CONVAIR

COMMERCIAL CHANGE PROPOSAL

SPEC NO.: ZD-22-327 DATE: _____
 CUSTOMER: JAL MCL 15,037 DTD _____
 CHANGE NO: 93 MODEL: 22-3 (22M)

TITLE: Specification Administrative Change (Revision to Portable Oxygen Bottle Part Number - Group C Airplanes)

PILOT'S AND CO-PILOT'S PEDESTAL

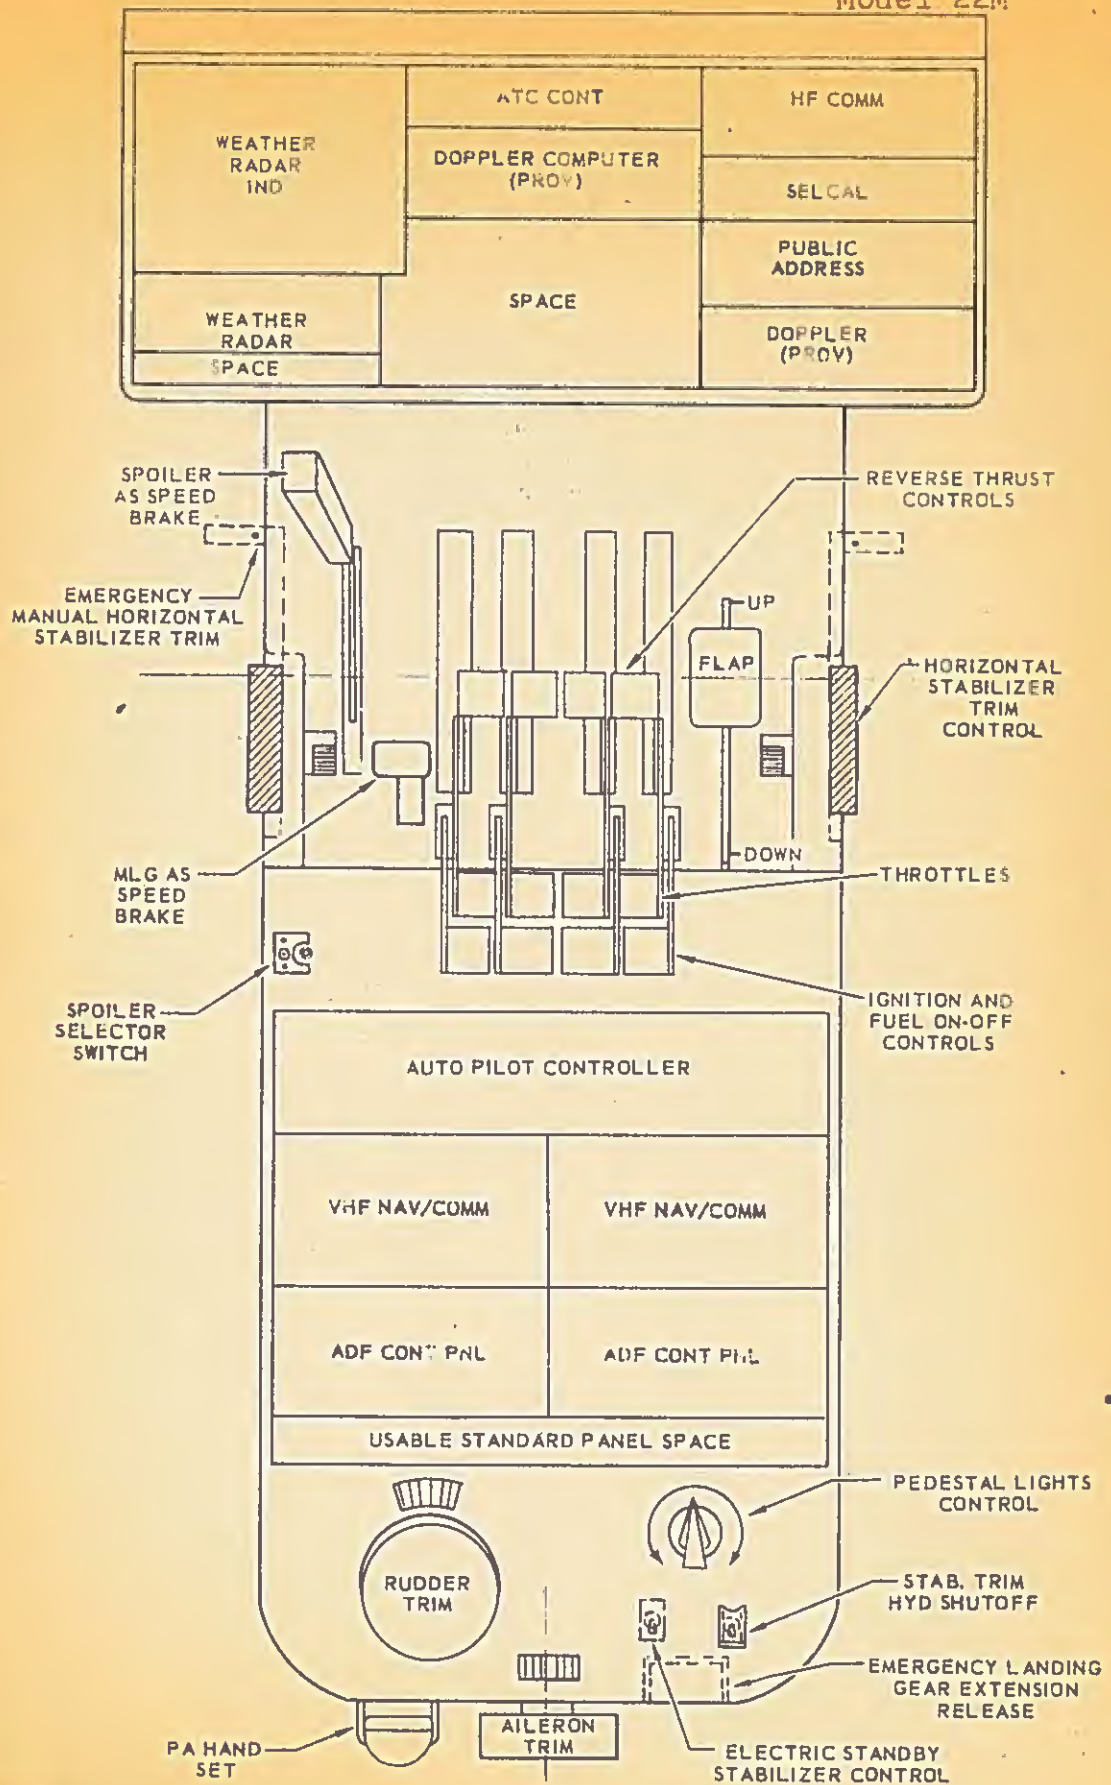
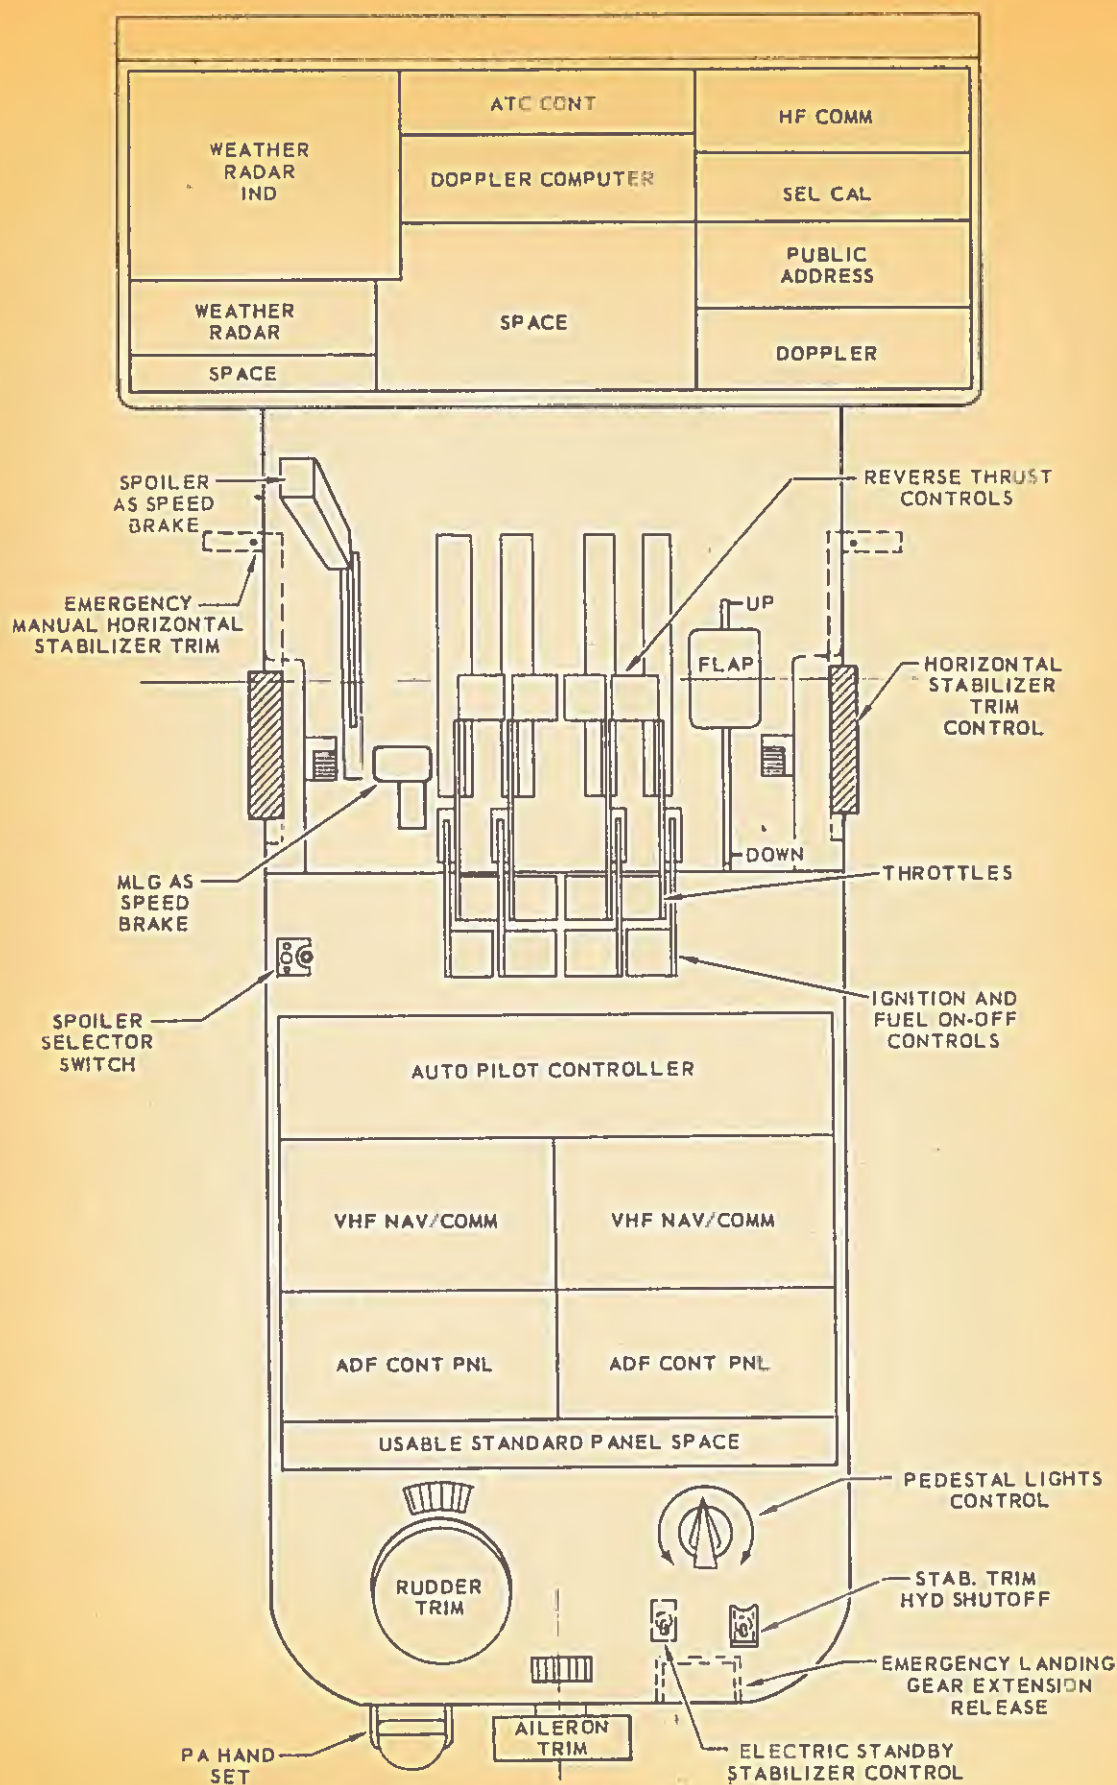
Revise above illustration to show ship effectivity 1, 2 and 3.

Add the above illustration which shall show ship effectivity 4 and 5, and the installation of a Doppler computer control panel.

FLIGHT INSTRUMENTATION DIAGRAM

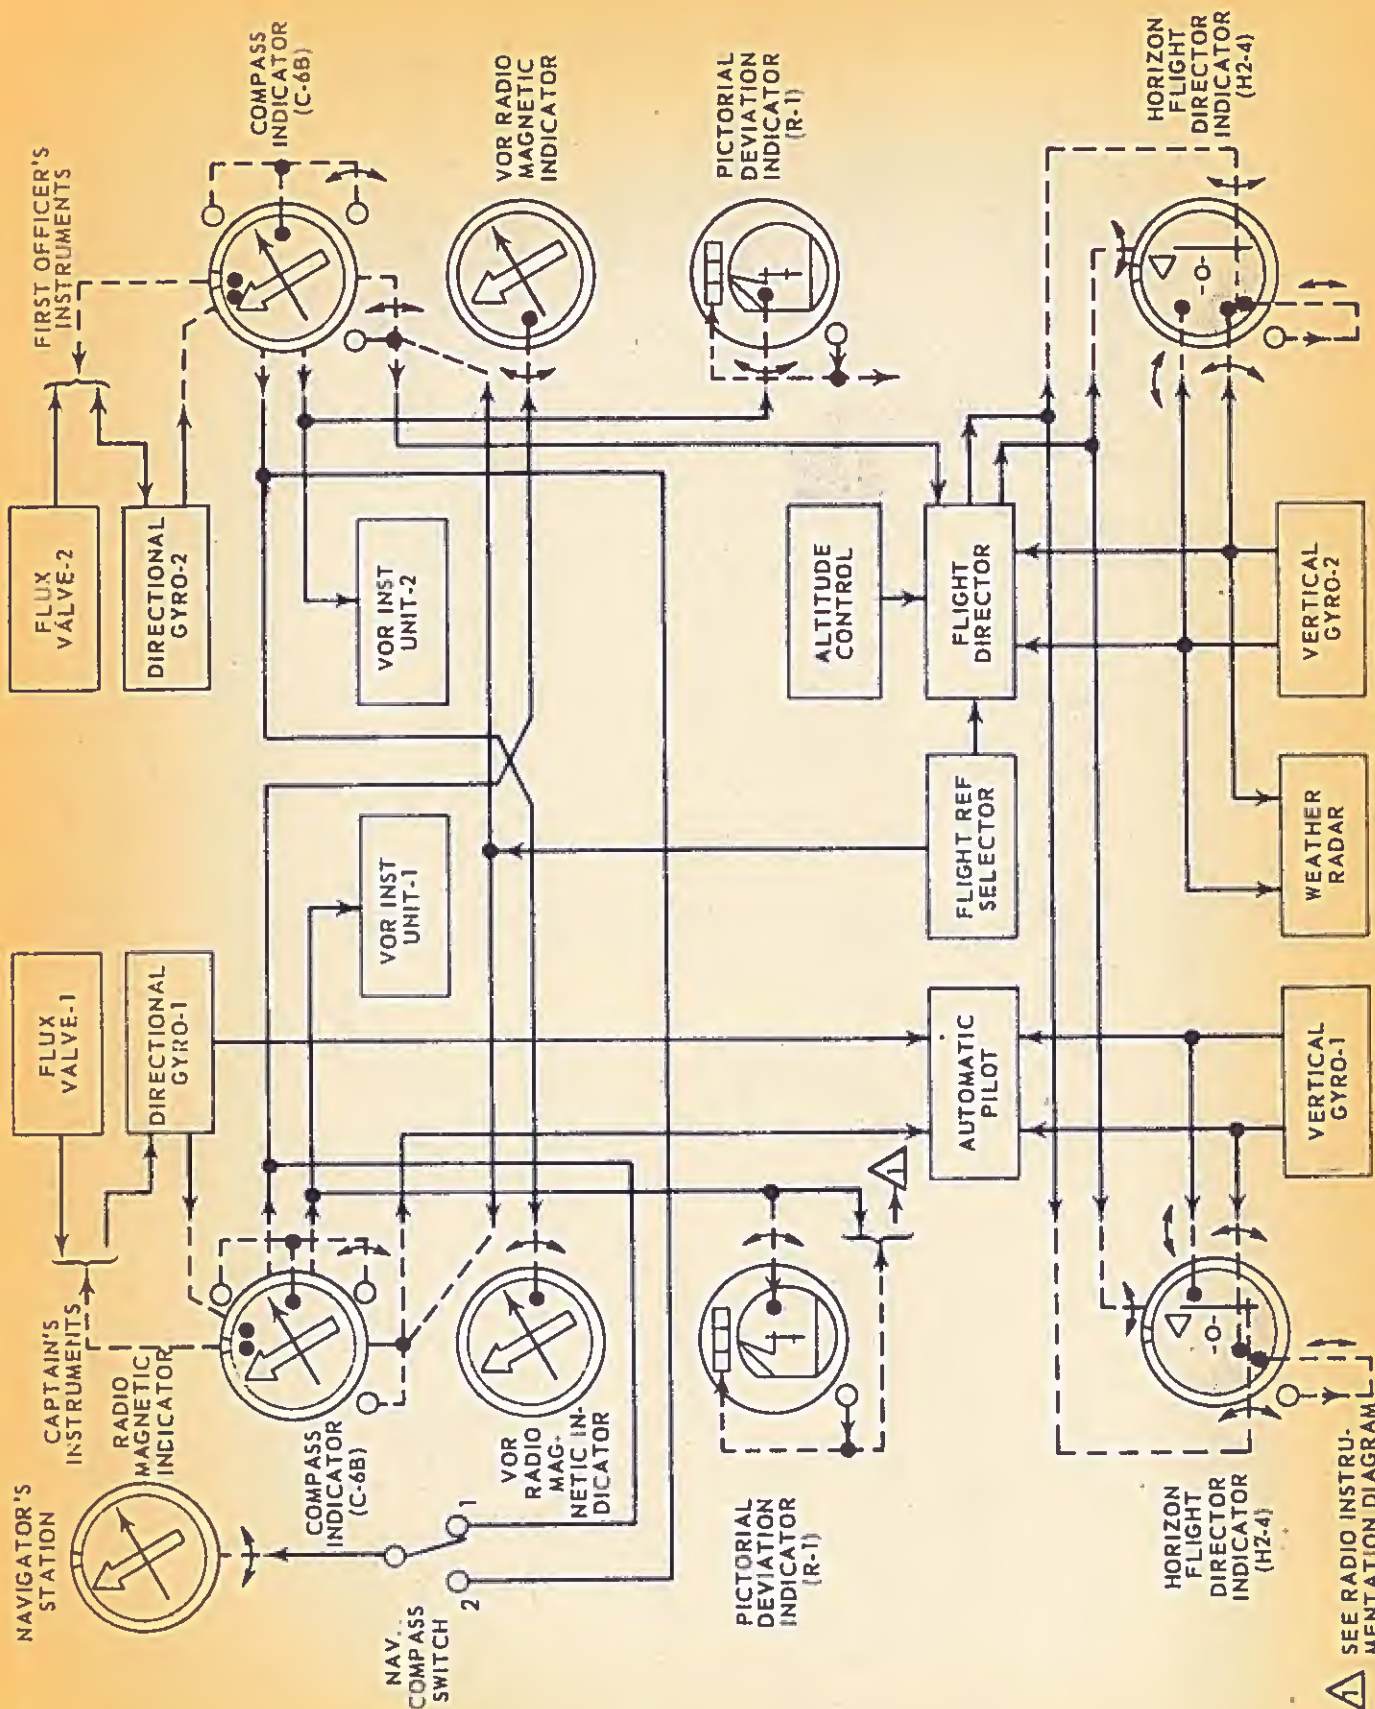
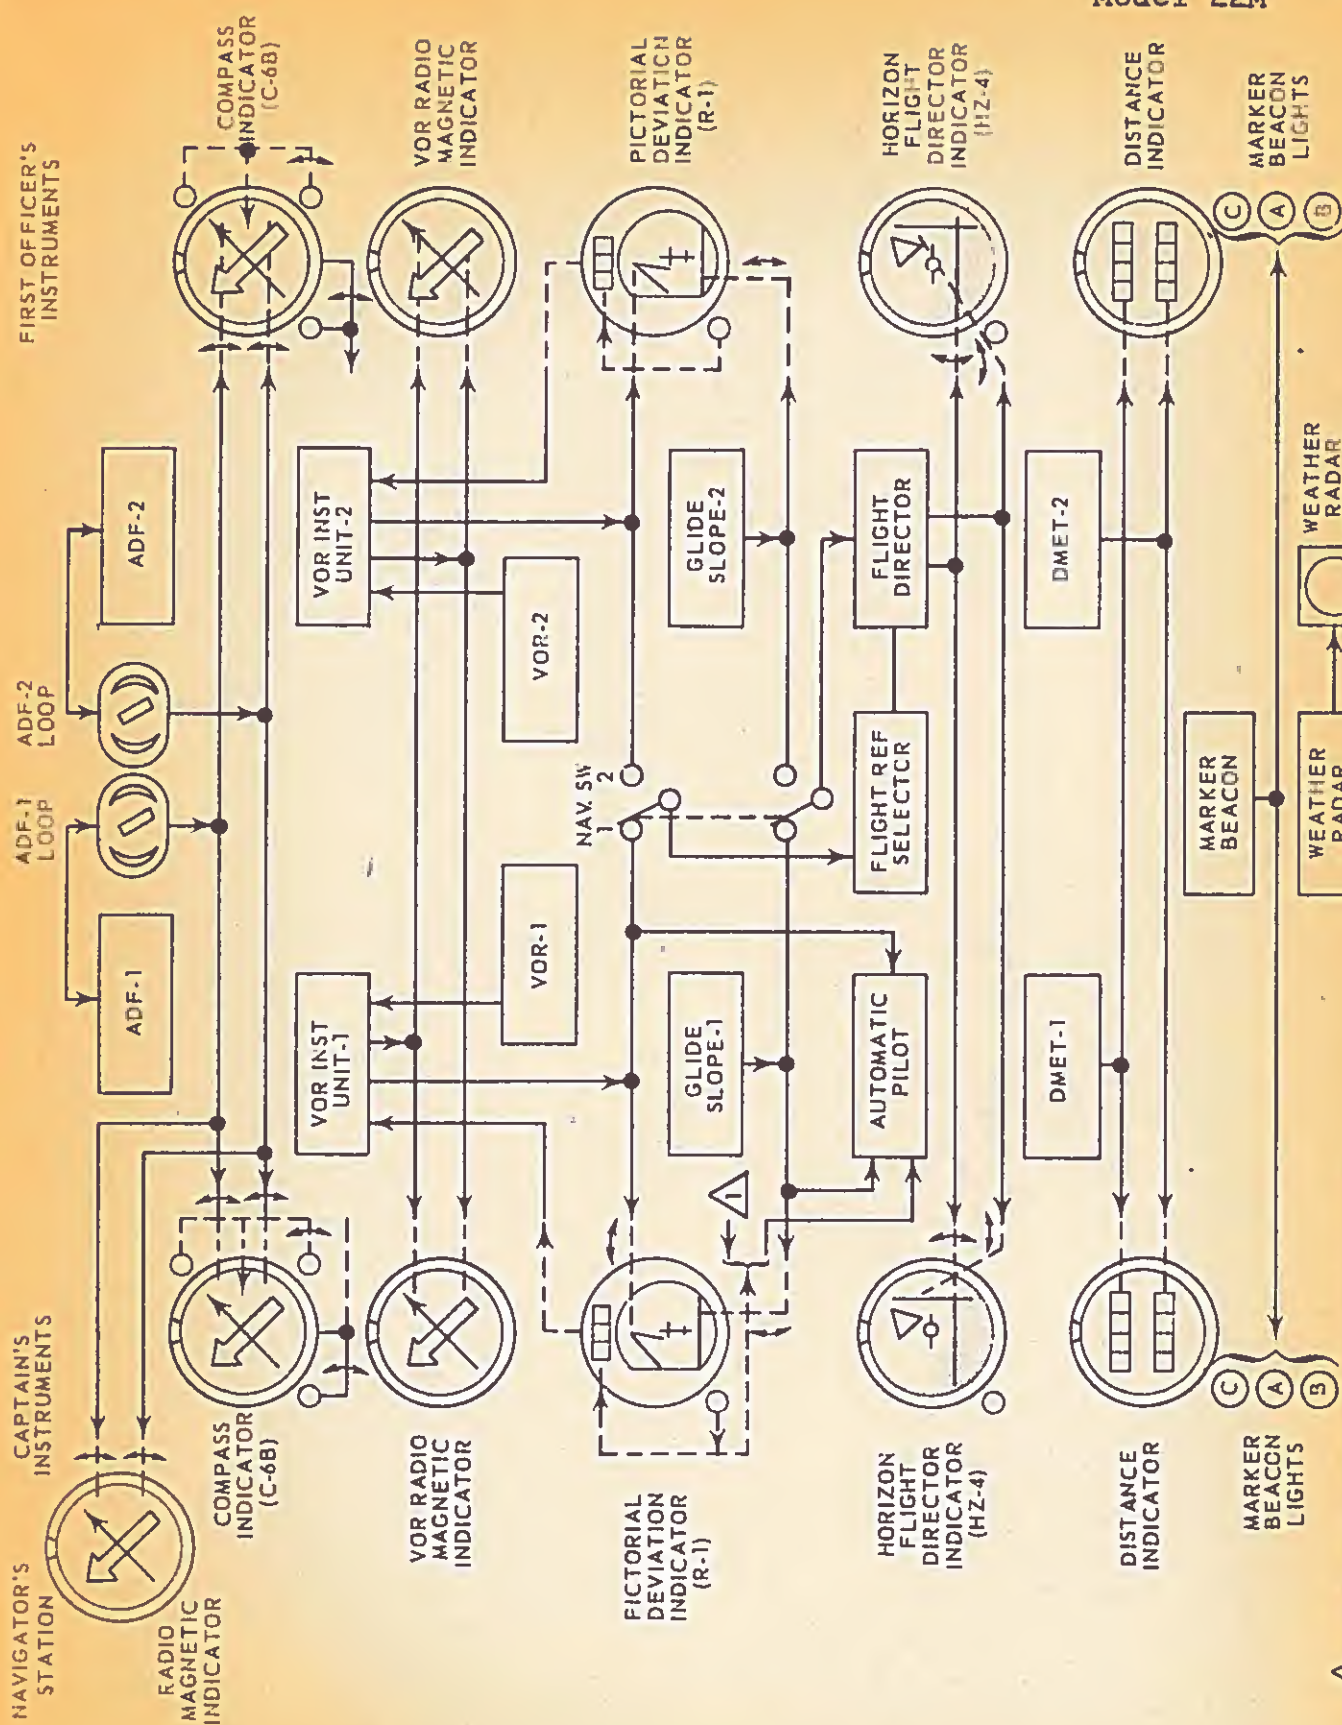
Page 79, Paragraph 3.17.3.4.1 CONTROLS:

Delete all description after the second sentence, and add the following new paragraphs, after Paragraph 3.17.3.4.2:

"3.17.3.4.3 INSTRUMENTATION: Pilot's PDI (R-1) shall display information from No. 1 VHF navigation system and No. 1 glide slope, whereas copilot's PDI shall display information from the No. 2 VHF navigation system and No. 2 glide slope. The course selector of pilot's PDI shall supply signal to the No. 1 VHF navigation system, whereas the course selector of copilot's PDI shall supply signal to the No. 2 VHF navigation system. The single and double pointers on pilot's and copilot's RMI shall display information from the No. 1 and No. 2 VHF navigation systems respective. The automatic pilot shall receive deviation and mode control signals from the No. 1 VHF navigation system and No. 1 glide slope, and shall receive VOR selected course signals from pilot's PDI.

3.17.3.4.4 VHF NAVIGATION SIGNAL FOR FLIGHT DIRECTOR: A flight director transfer switch with "VOR/ILS-1" and "VOR/ILS-2" positions shall be installed. Two flags, each with "VOR/ILS-1" and "VOR/ILS-2" positions shall be installed. (See Page 44a.) When the transfer switch

PILOT'S AND COPILOT'S INSTRUMENT PANELS

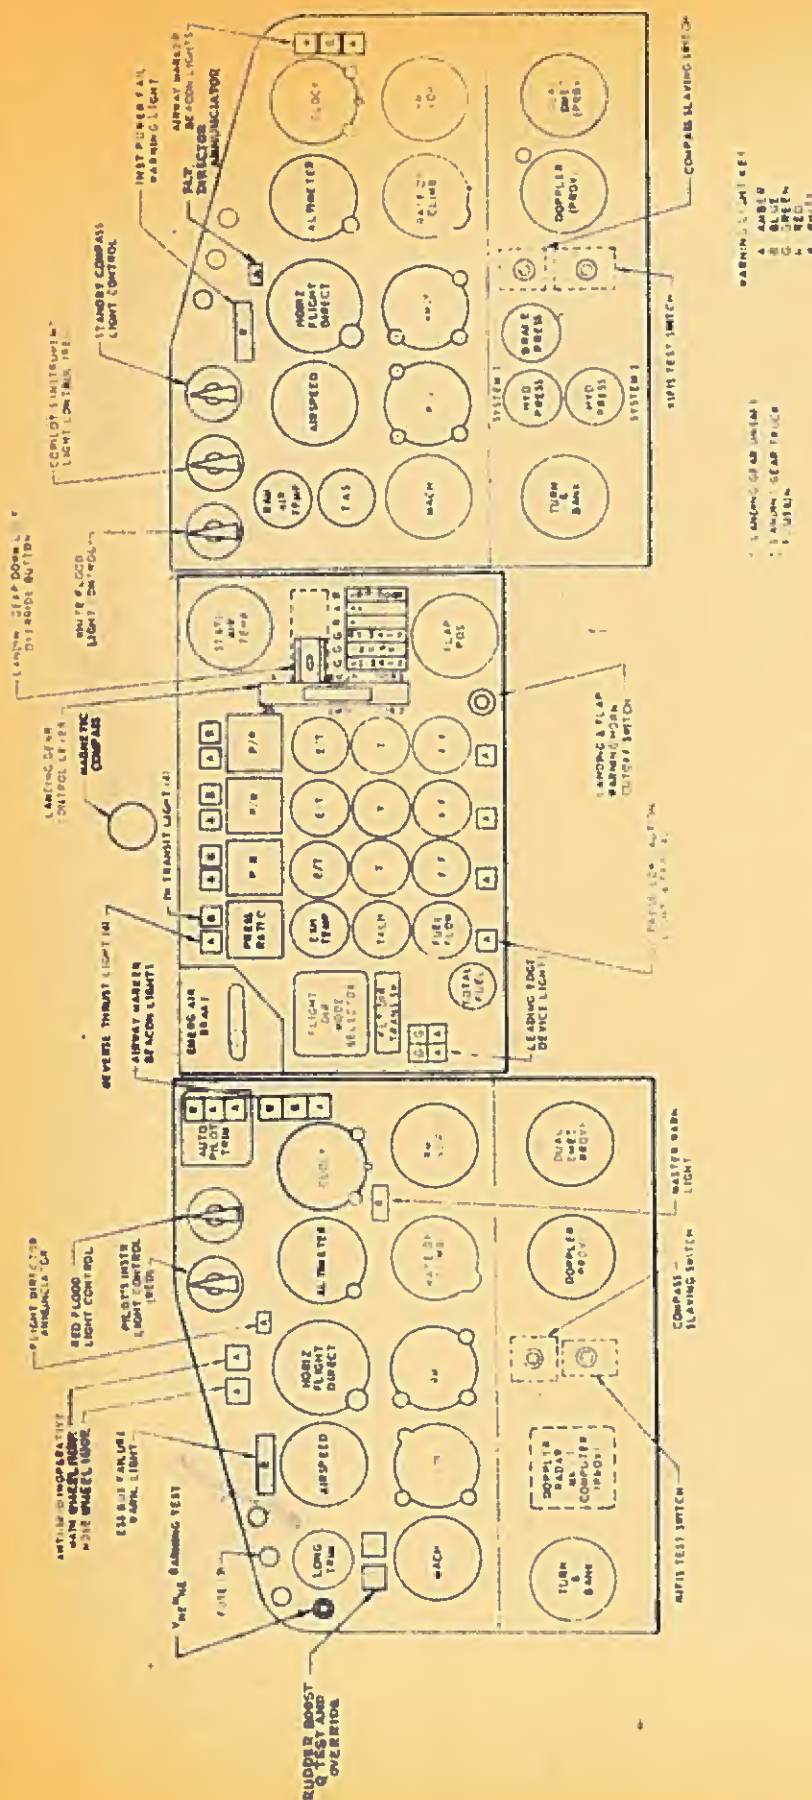
Page 44a, PILOT'S AND COPILOT'S INSTRUMENT PANELS:

Replace above illustration in the specification with Enclosure (A) which deletes "MAIN LANDING GEAR" and "NOSE LANDING GEAR" on pilot's panel and adds "MAIN WHEEL INOP." and "NOSE WHEEL INOP."
